As Built Drawing

Contract No. DACW 33-76-C-0088

DES. BY W. F.	DR. BY W. F.	CK. BY W. F.	DATE 1 June 76	DESCRIPTION Final Field Corrections Rim and Invert E's added (Am. #4)	BY W. F.
DEPARTMENT OF THE ARMY NEW ENGLAND DIVISION CORPS OF ENGINEERS WALTHAM, MASS.					
WATER RESOURCES DEVELOPMENT PROJECT PARK RIVER LOCAL PROTECTION BOX CONDUIT AT SECTION 7 LOW LEVEL DRAINAGE PROFILES					
APPROVAL RECOMMENDED PROJECT ENGINEER APPROVED CHIEF, PROJECT BRANCH			HARTFORD CONNECTICUT DATE MARCH 1976		
SCALE AS SHOWN SPEC. NO. DACW 33-76-8-6040 DRAWING NUMBER PAR - I

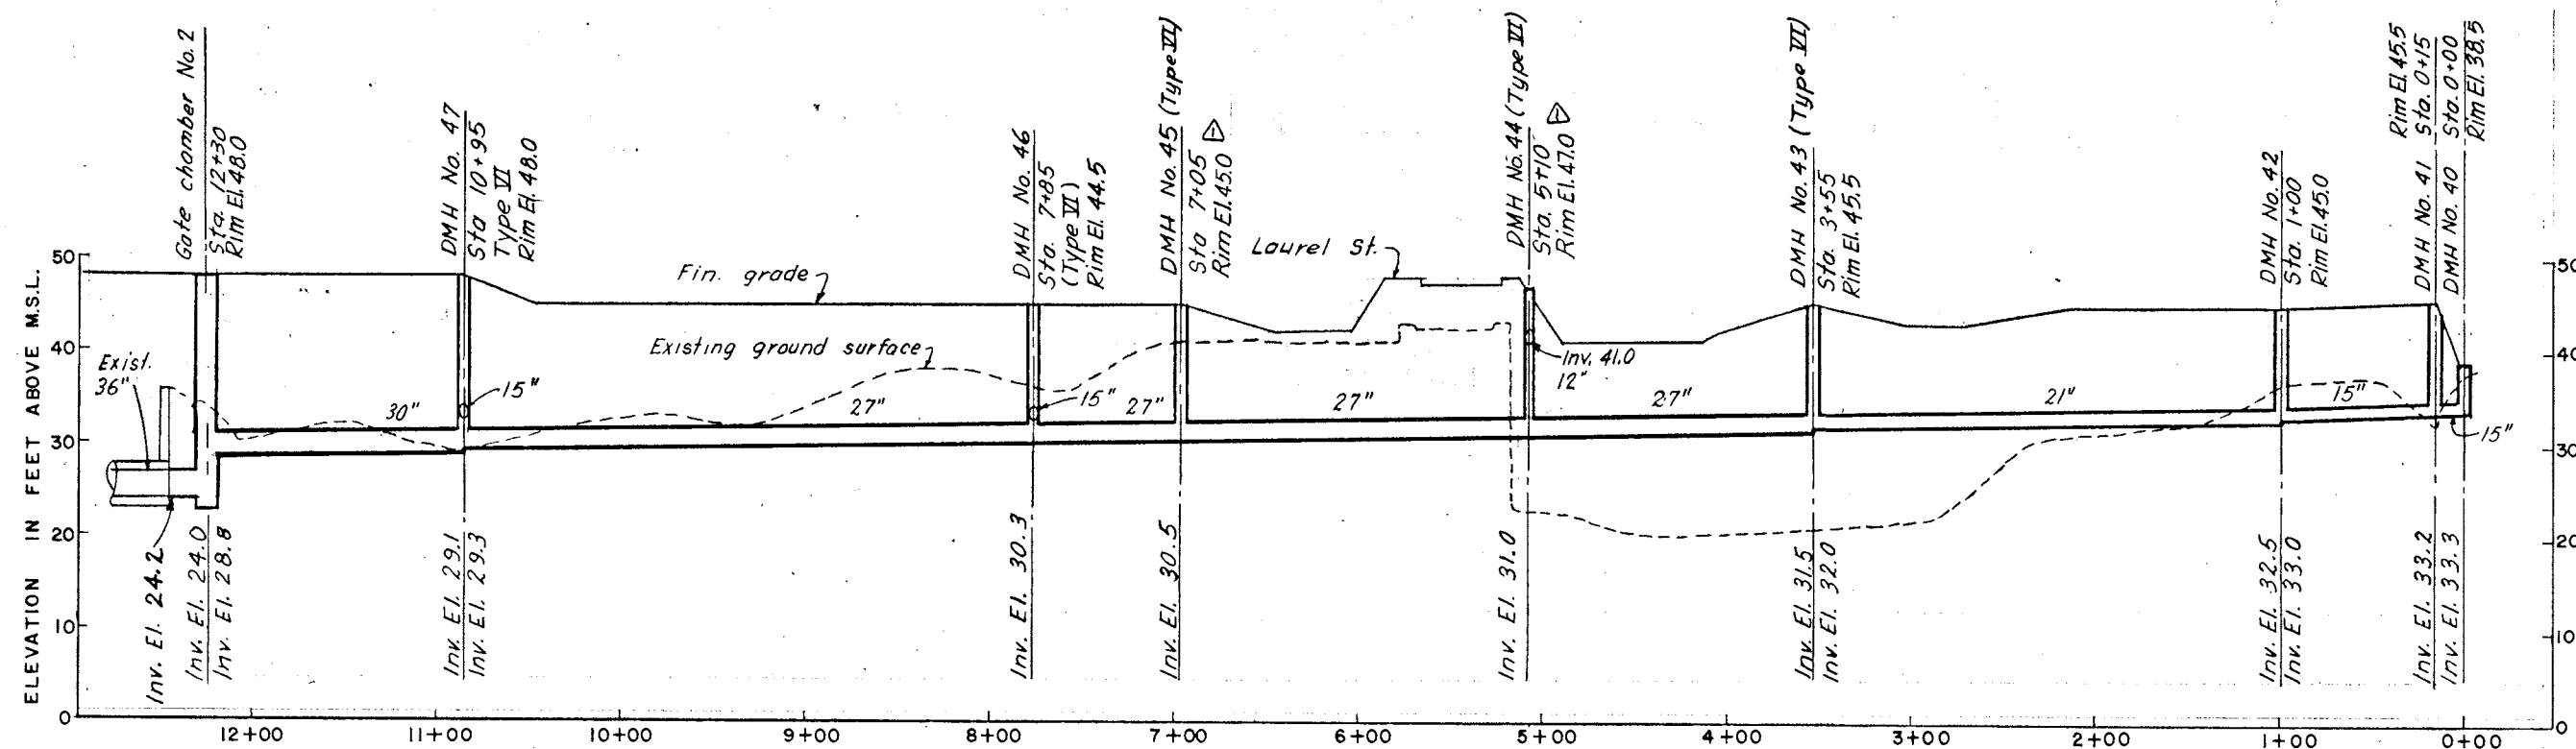
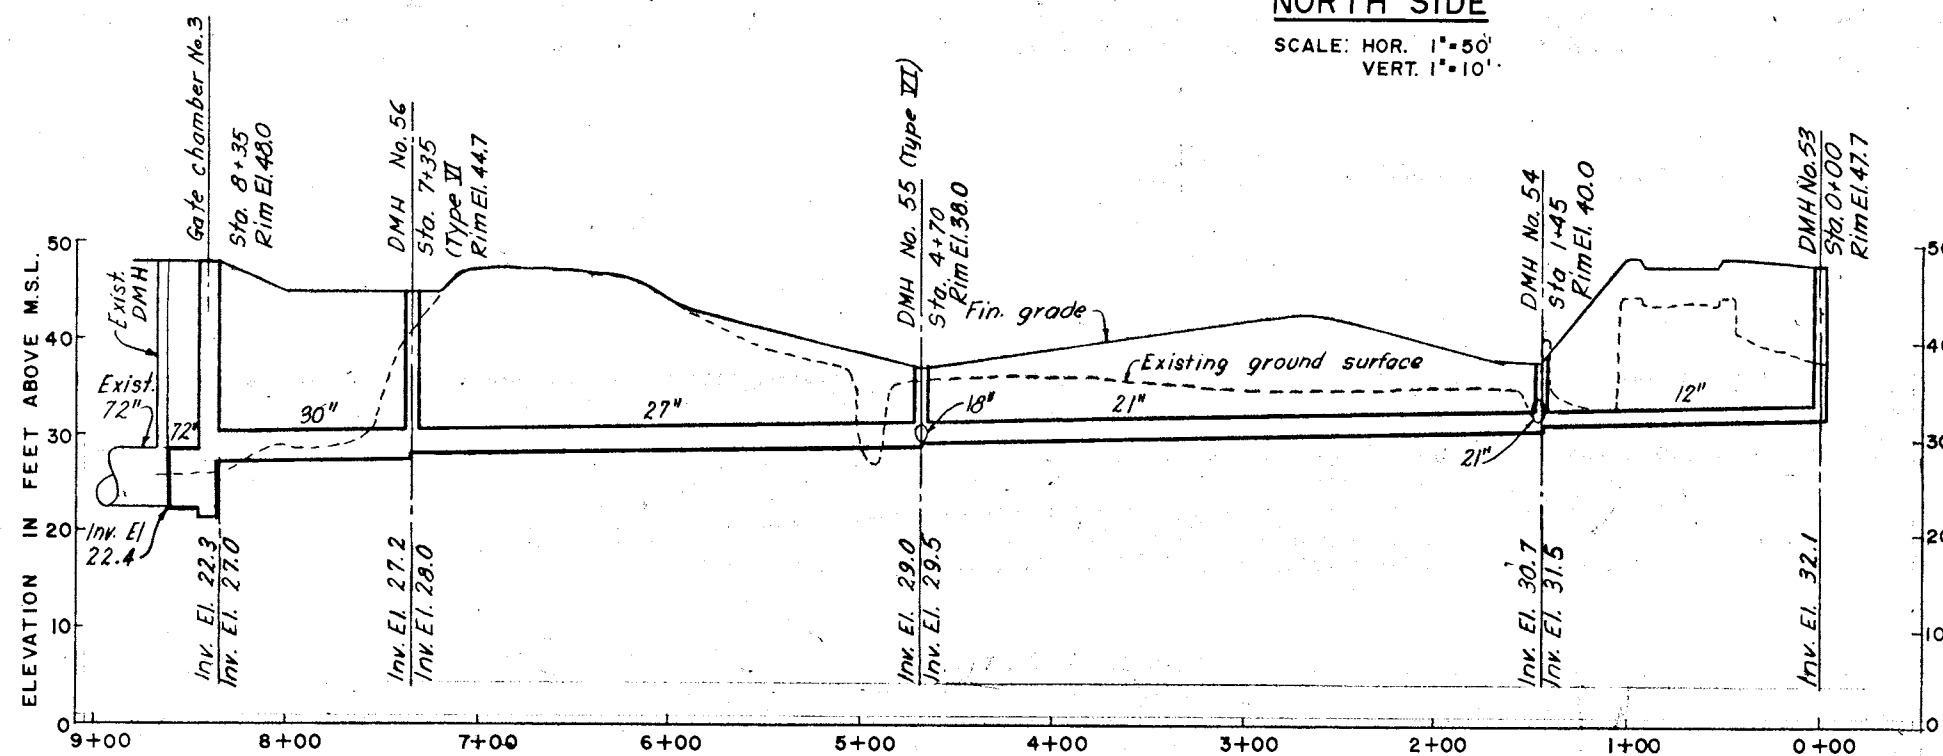
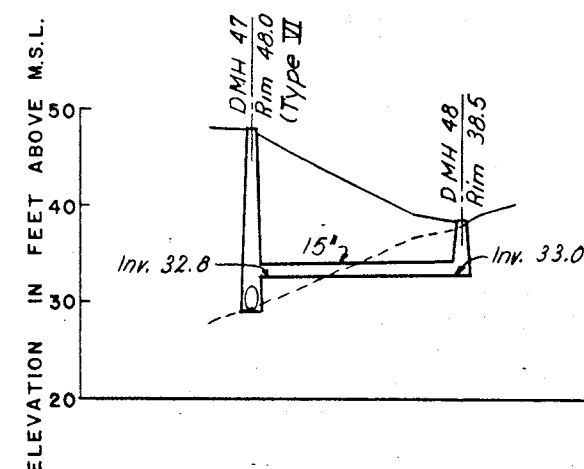
1. For location of low level drains see sheets 58 and 59.
2. All manholes shall be Type II unless otherwise noted.
3. Change DMH Nos. 43, 44, 45 & 55 from Type II to Type VI.
